ADDENDUM NUMBER 1

CITY OF LEMOORE

BUSH STREET PEDESTRIAN SAFETY IMPROVEMENTS PROJECT HIGHWAY SAFETY IMPROVEMENT PROGRAM (HSIP CYCLE 10) HSIP-5115(040)

January 16, 2024

MATERIAL LIST

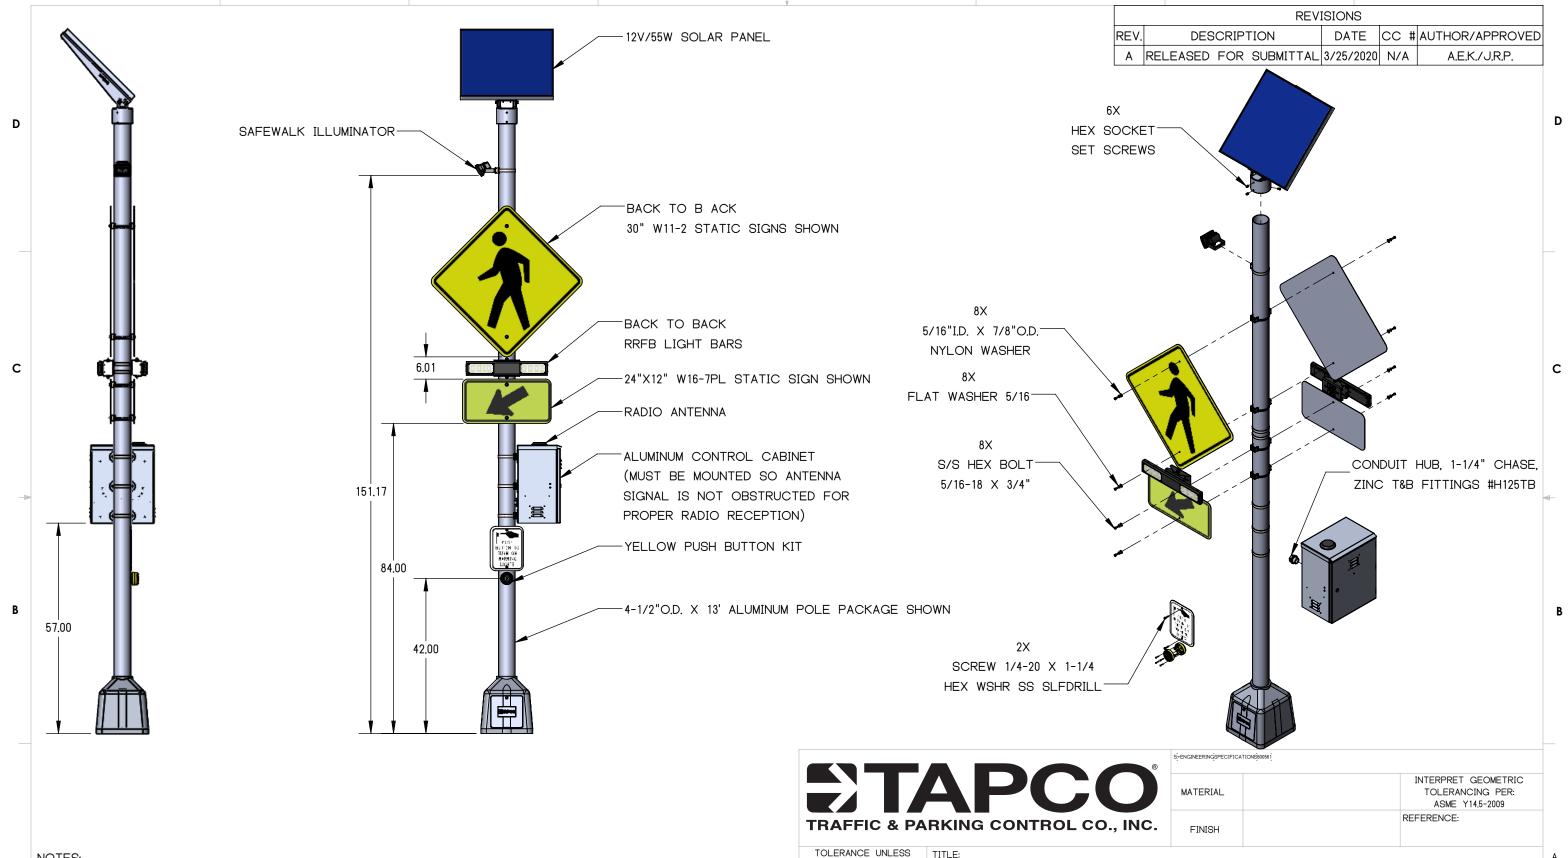
• Replace In-Road Light System with RRFB Crosswalk Solar-Powered, Radio, Push Button Activated Warning System w/Crosswalk Illuminator (Or Equal) as shown on the attached documents herein.

SHEET NO.

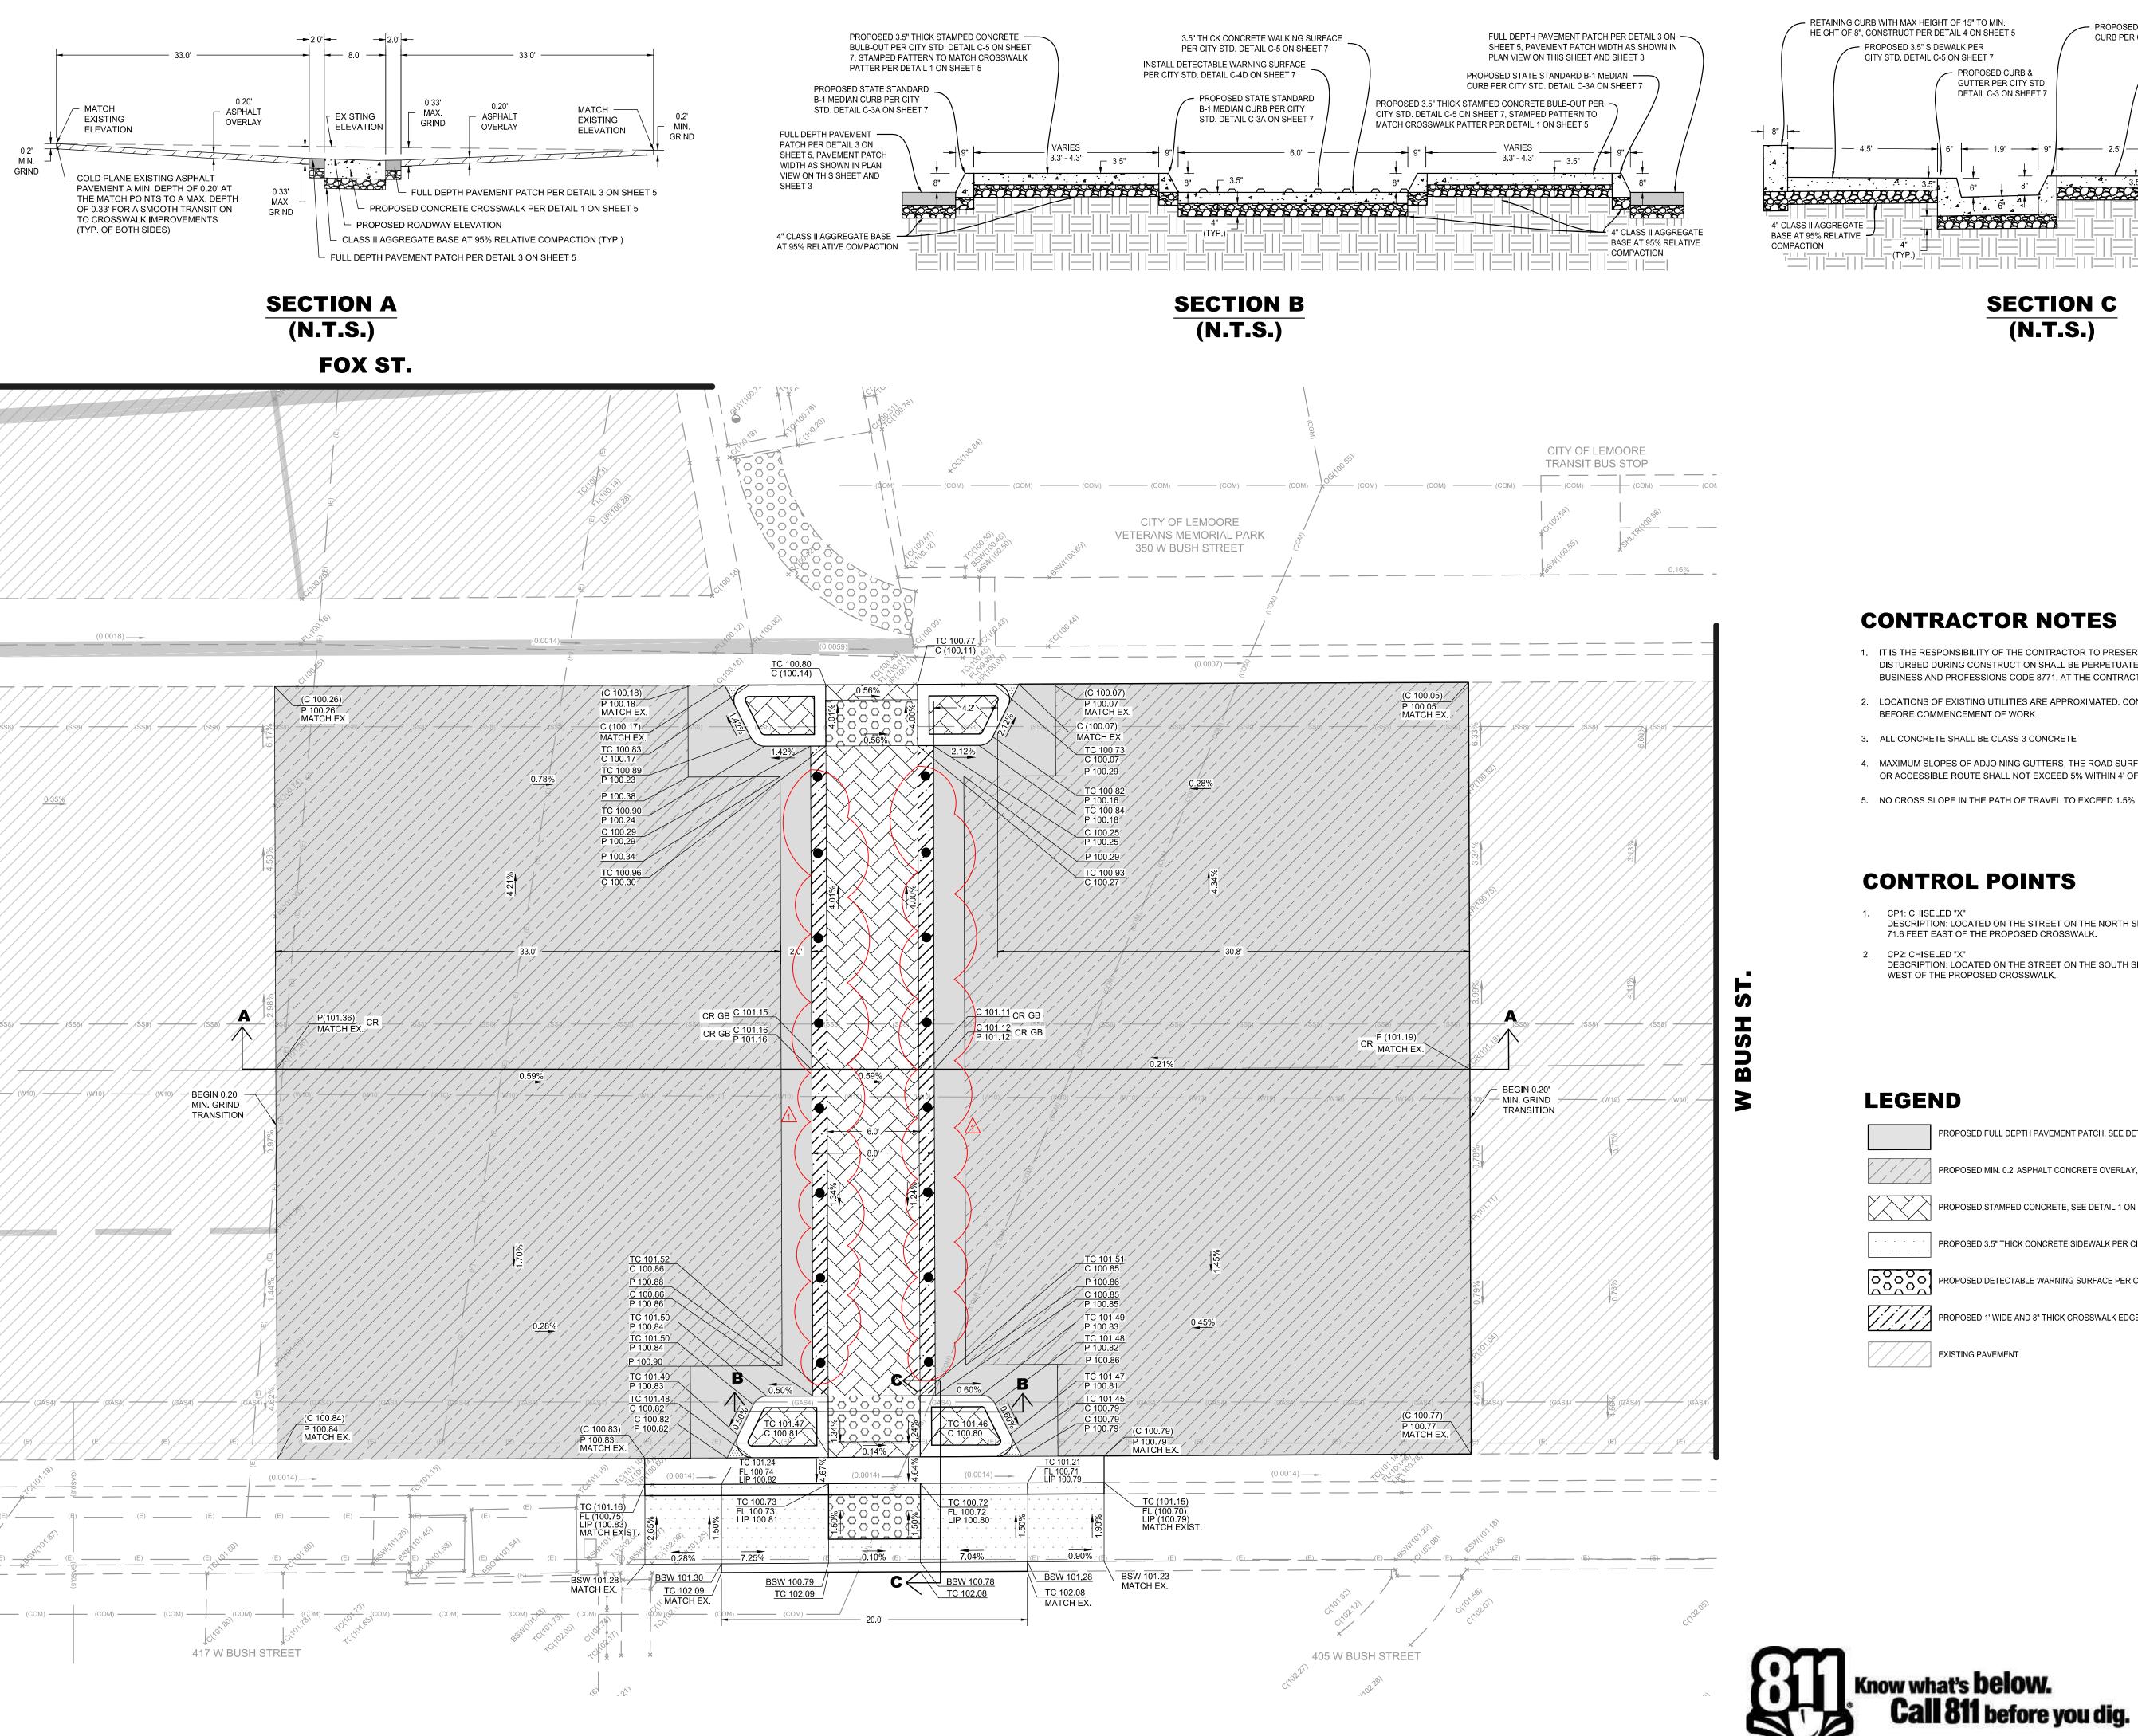
REPLACE IN-ROAD LIGHT SYSTEM WITH RRFB SOLAR POWERED, RADIO, PUSH BUTTON ACTIVATED WARNING SYSTEM W/CROSSWALK ILLUMINATOR

SHEET NO.

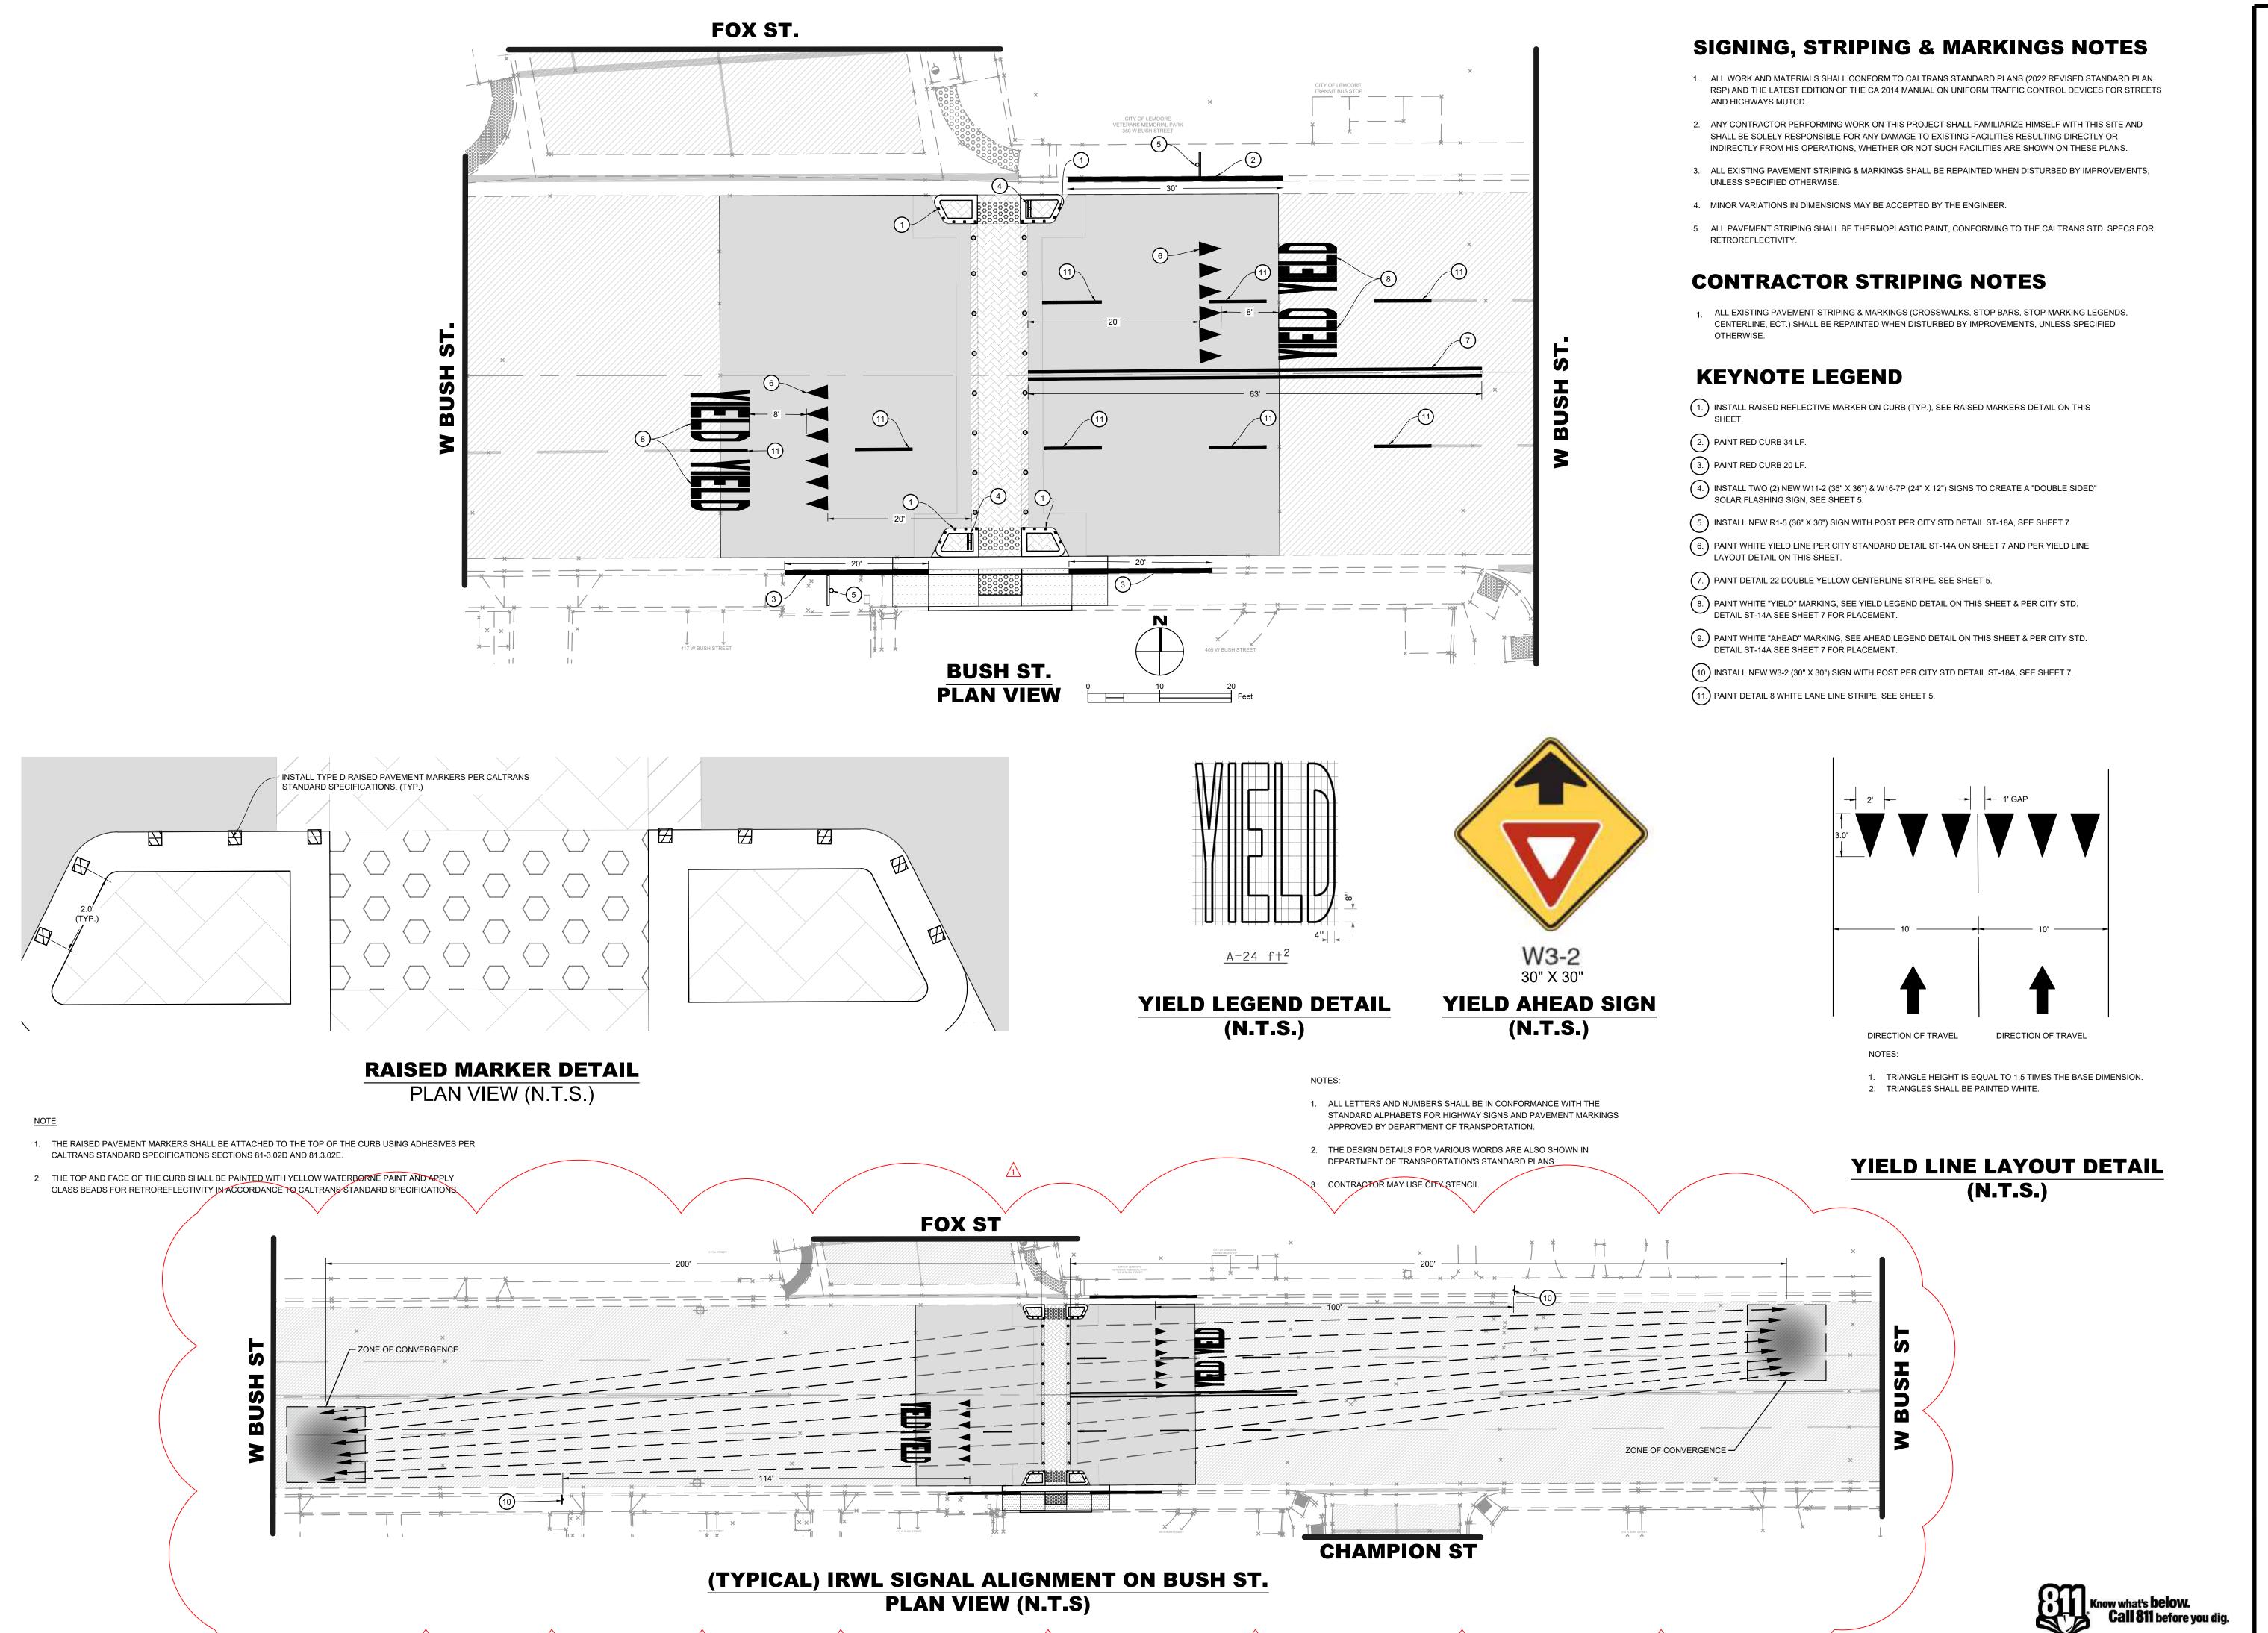
REPLACE IN-ROAD LIGHT SYSTEM WITH RRFB SOLAR POWERED, RADIO, PUSH BUTTON ACTIVATED WARNING SYSTEM W/CROSSWALK ILLUMINATOR
